**Version: October 15, 2024**

**Oregon Supplement to the  
Manual on Uniform  
Traffic Control Devices  
for Streets and Highways  
11th Edition**

This is a compilation of draft proposals for the Oregon Supplement to the MUTCD 11<sup>th</sup> Edition as of the version date above. This is not official Oregon Supplement content. This is provided for information only. ODOT might edit final proposed language to fit with the scope and style of the Oregon Supplement to the MUTCD.

**Figure 3I-1(OR). Examples of Tubular Markers Supplementing Pavement Markings in Advance of an Unsignalized Crosswalk**

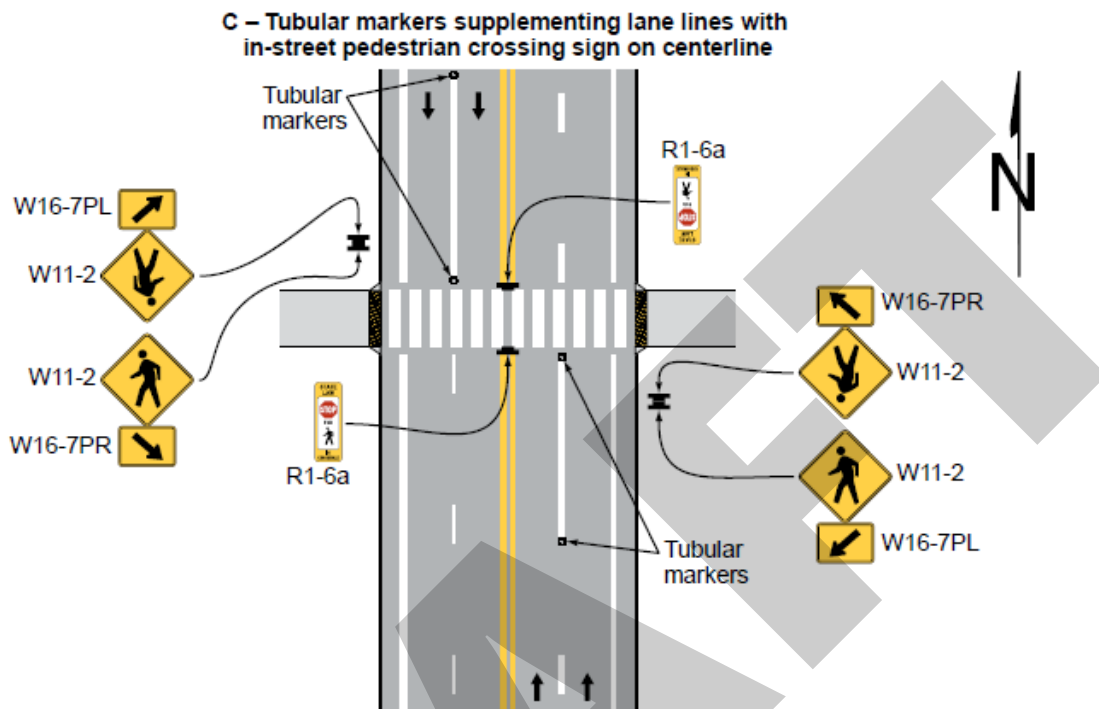
121 04 Tubular markers are sometimes used to provide additional emphasis or improve lane discipline in  
122 advance of an unsignalized crosswalk (see Figure 3I-1 [and Figure 3I-1\(OR\)](#)).

**Figure 3B-14(OR). Examples of Applications of Lane-Reduction Transition Markings**

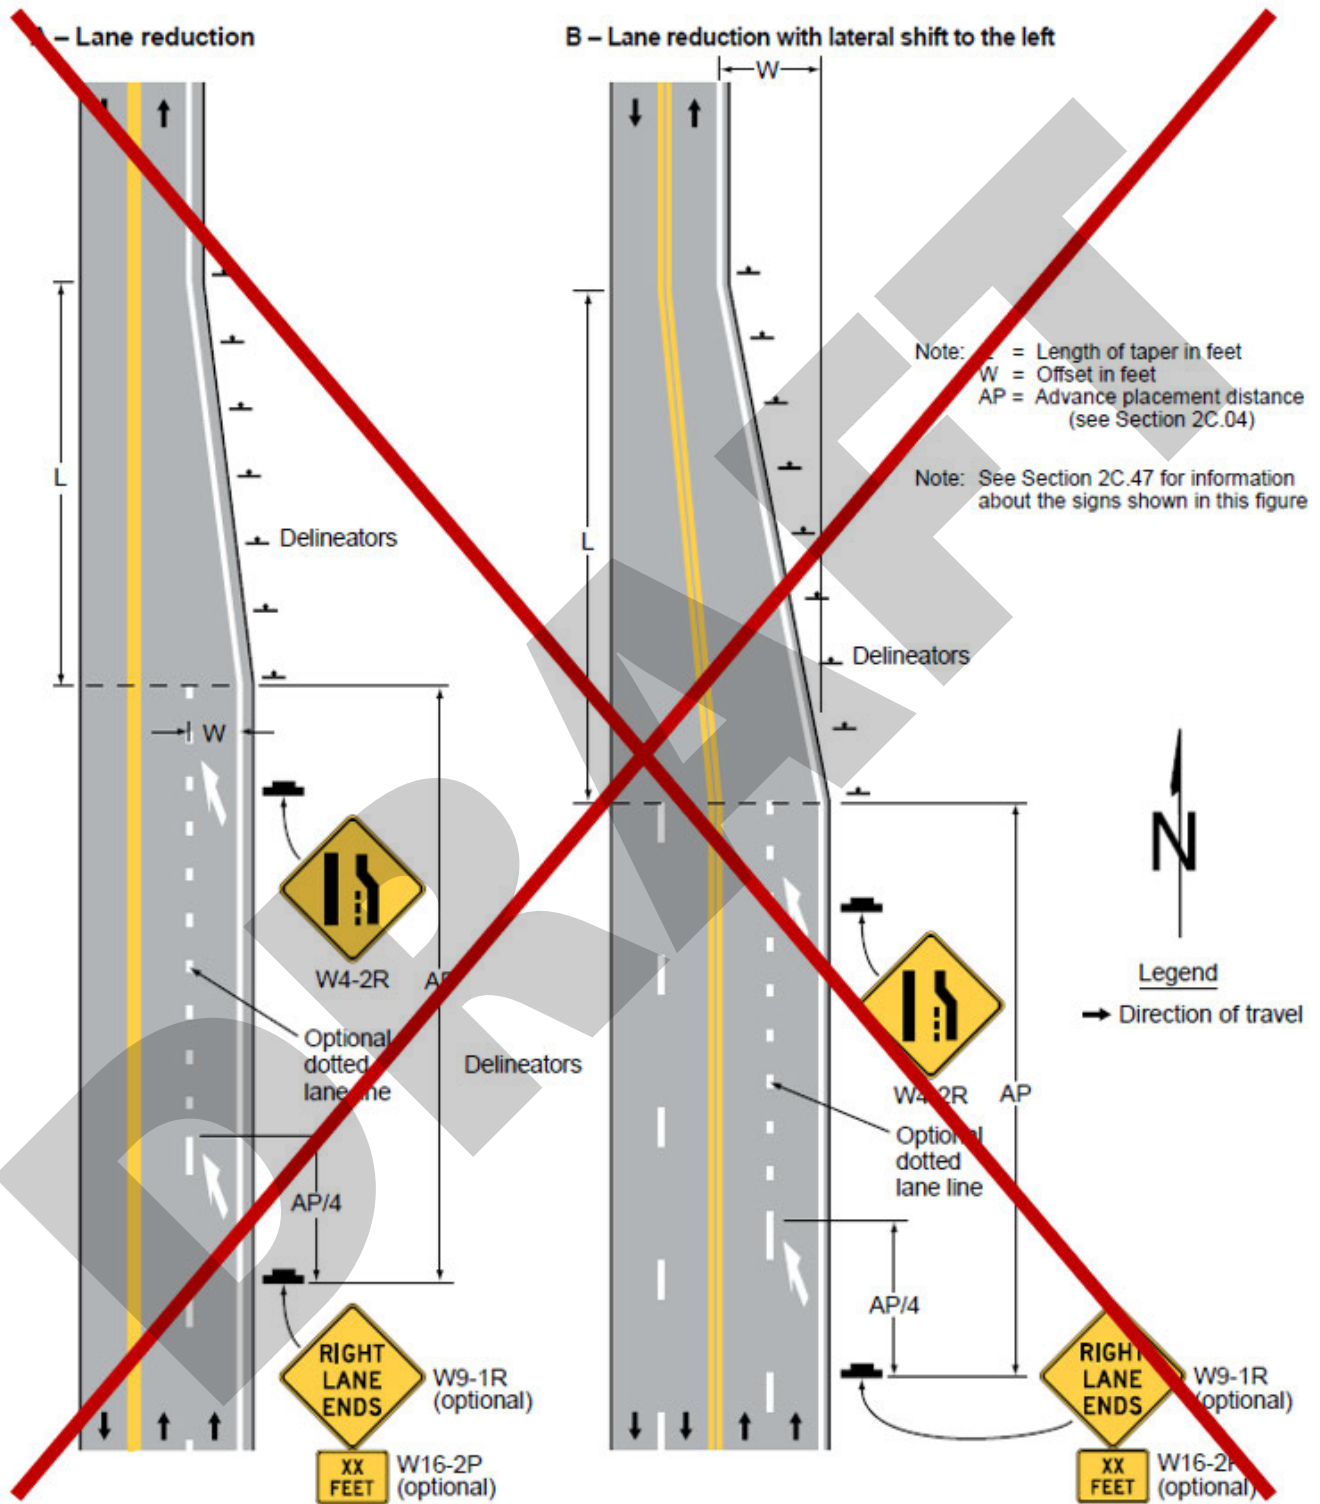
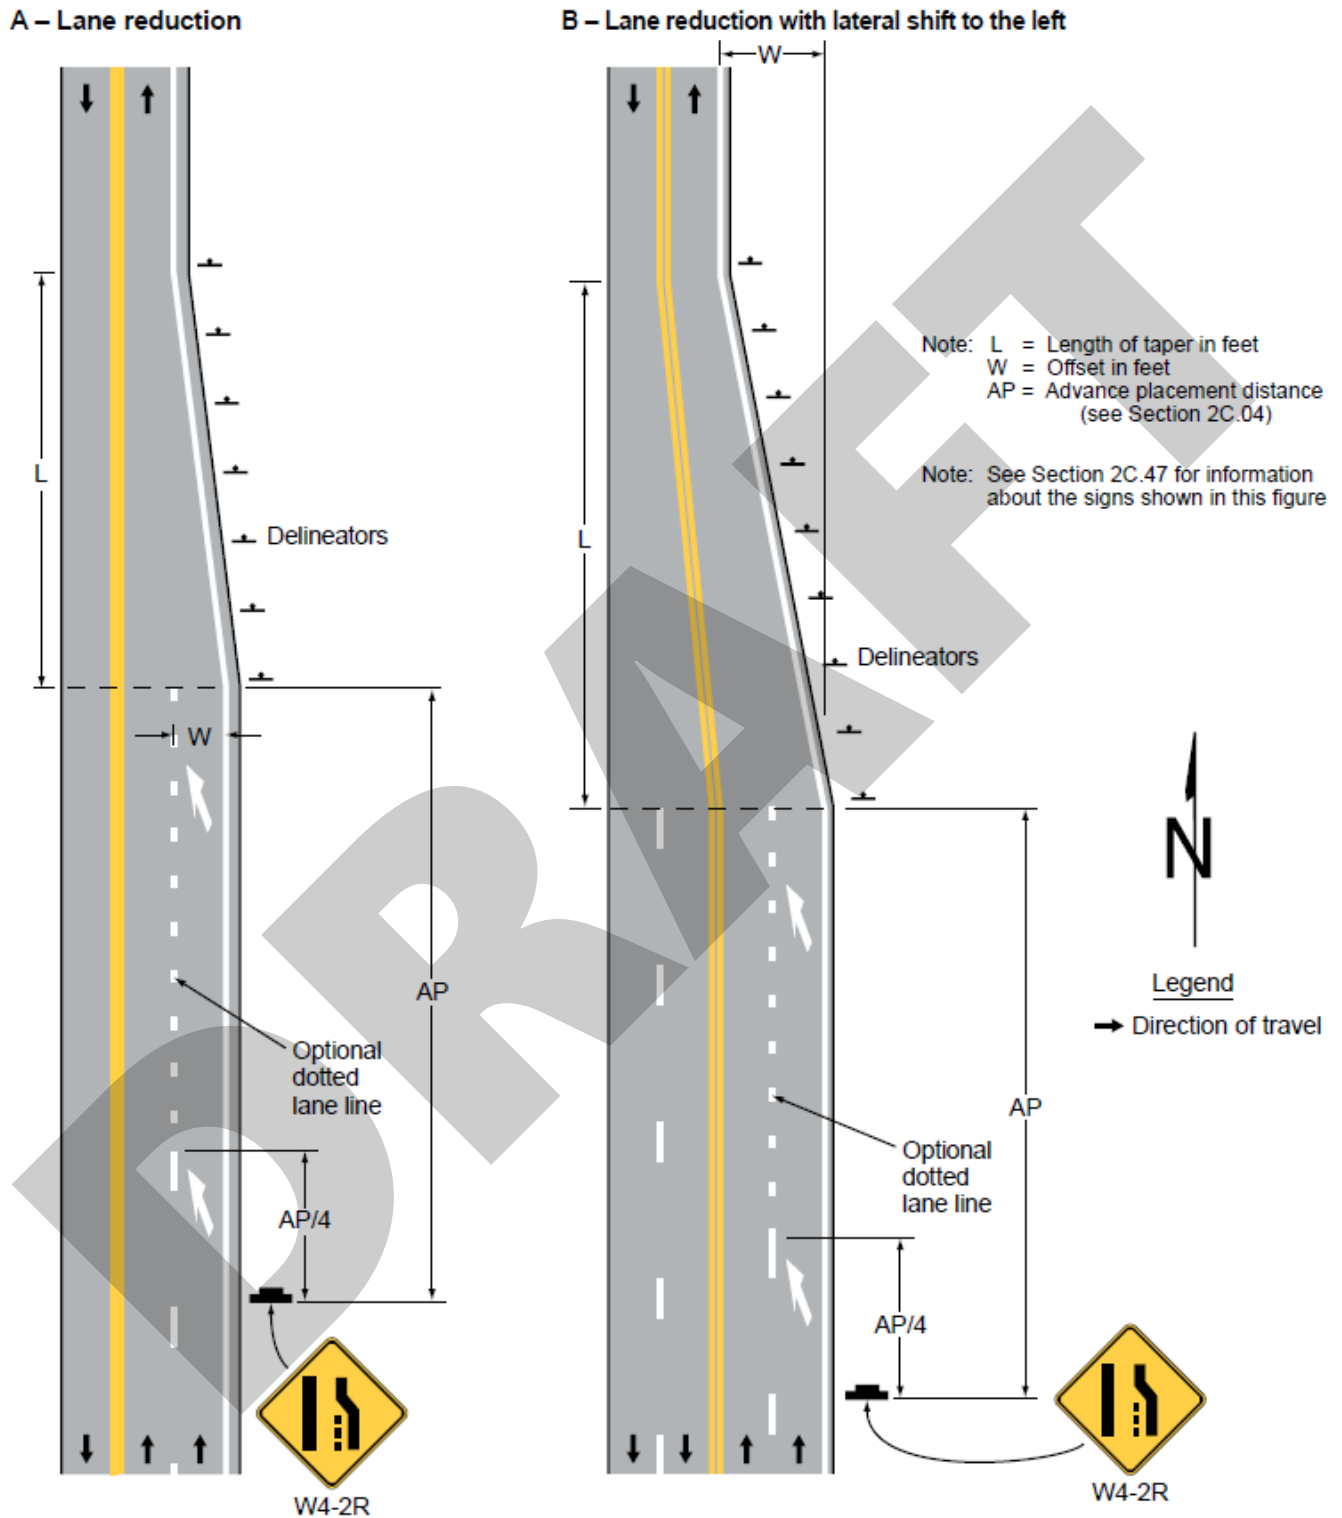
2 Figure 3B-14 in Section 3B.12 Lane Reduction Transitions is on FHWA’s known error list. In Figure 3B-  
3 14 the sign assembly is in the incorrect location. This can lead to incorrect sign placement at lane  
4 reductions if the Supplement does not address it.

6 FHWA published the know errors of the 11th Edition of the MUTCD. This proposes to address the  
7 known error of the sign placement in Figure 3B-14. The placement of sign W4-2R in Figure 3B-14  
8 moved to the correct location.

**Figure 8B-7(OR). Railroad Stop Sign Placement**

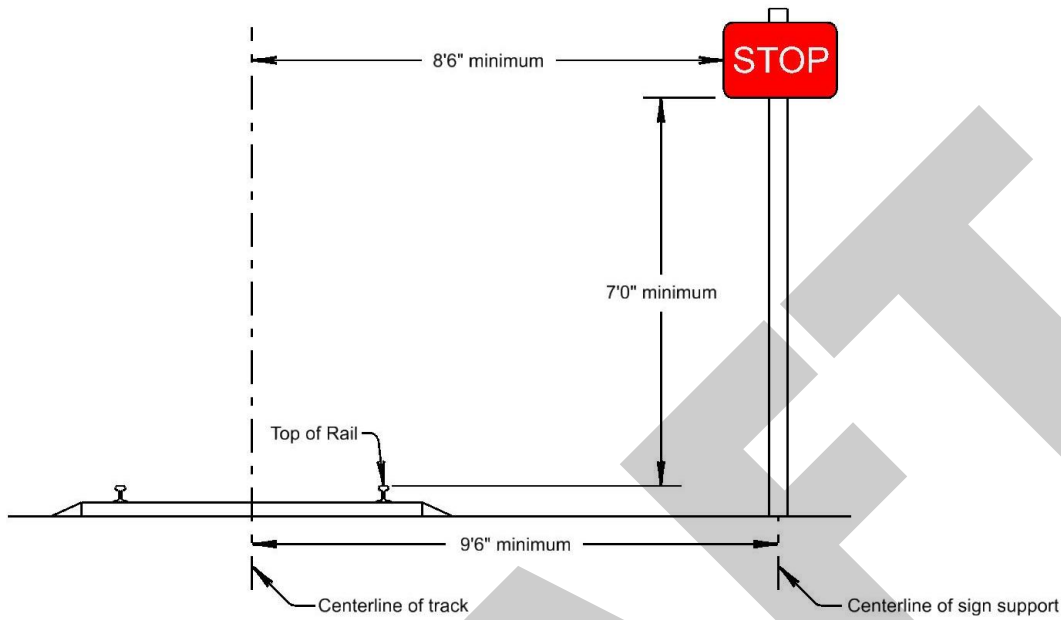
01 When a train is required to stop prior occupying the grade crossing, a railroad stop sign (see  
17 Figure 8B-6(OR)) shall be used. The sign shall be located on each track approach as shown in Figure  
18 8B-7(OR).

22 **Figure 8B-9(OR). Private Crossing Sign Placement**

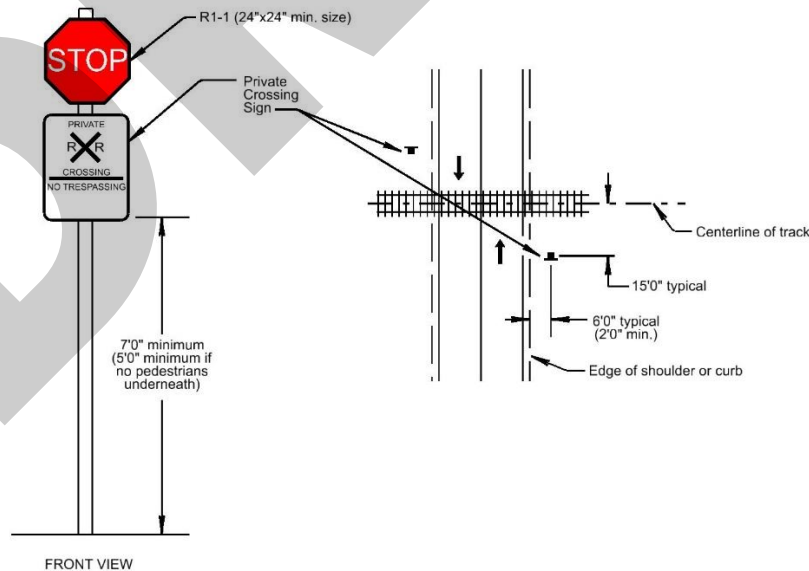
15 01 Private crossings, including farm crossings, that are not equipped with flashing light signals or  
16 automatic gates shall install a STOP (R1-1) sign with private crossing sign (see Figure 8B-8(OR)) on  
17 each side of the crossing as shown in Figure 8B-9(OR).

**Figure 8D-3(OR). Legacy Light Rail Transit and BRT Signal Indications**

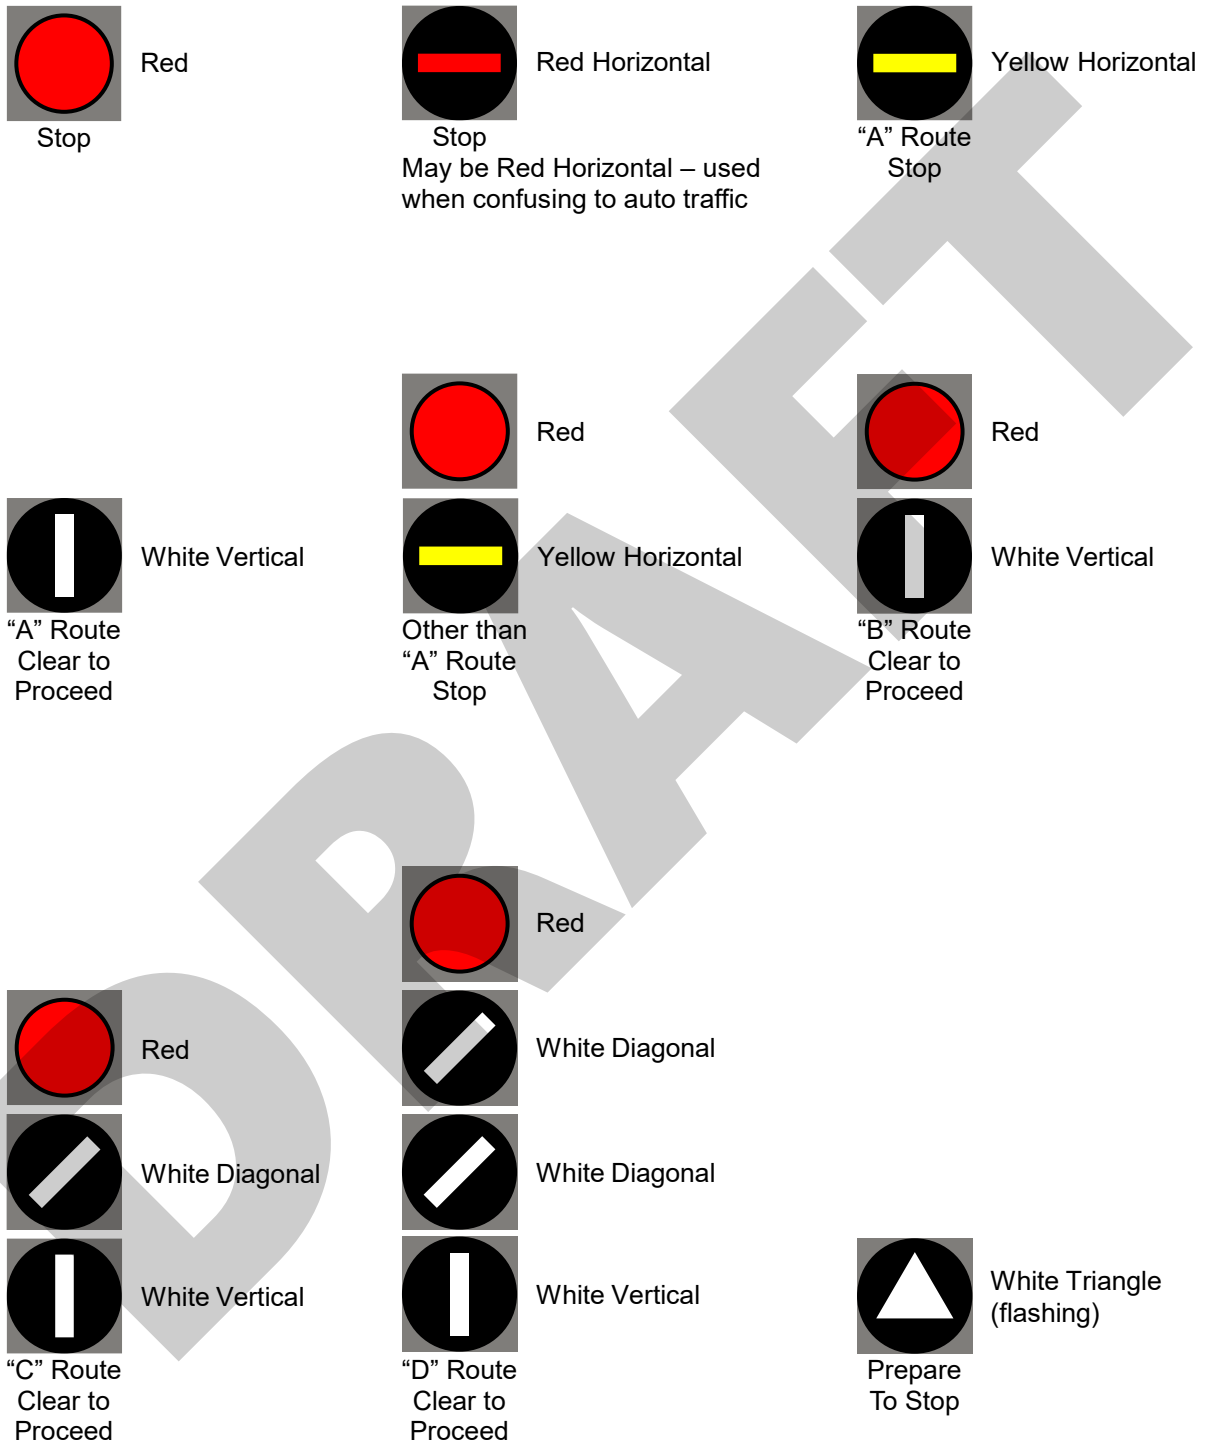
2 Oregon transit agencies have transit signals that were developed prior to their inclusion in the  
3 MUTCD. The Oregon Supplement should provide information on existing legacy LRT/BRT system  
4 signal indications to show different messages that are not possible to convey with the indications  
5 shown in the Figure 8D-3 in the 11th Edition of the MUTCD.

15 All new LRT/BRT systems should use the Figure 8D-3.

18 **Figure 2: MUTCD 11<sup>th</sup> Edition, Figure 8B-2**

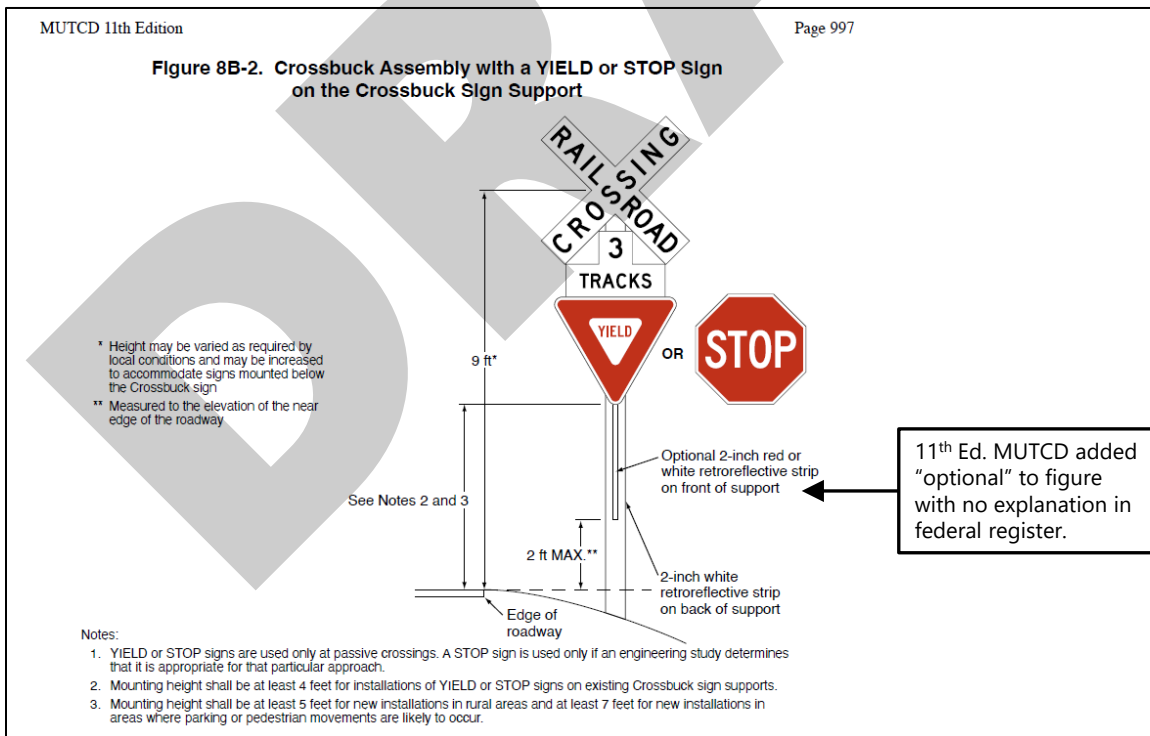
2 Figure 8B-2 in the 11<sup>th</sup> Edition is not clear on whether a reflective strip is required or optional  
3 (regardless of the color used).

5 Oregon believes the intent of Section 8B.04 Paragraph 19 is to only offer a choice on the color of  
6 reflective strip used (red or white) and NOT a choice for omitting the reflective strip altogether.  
7 Uniformity and enhanced conspicuity of the sign support for crossbuck signs at ALL passive grade  
8 crossings has been an important feature based on a review of past MUTCD history:
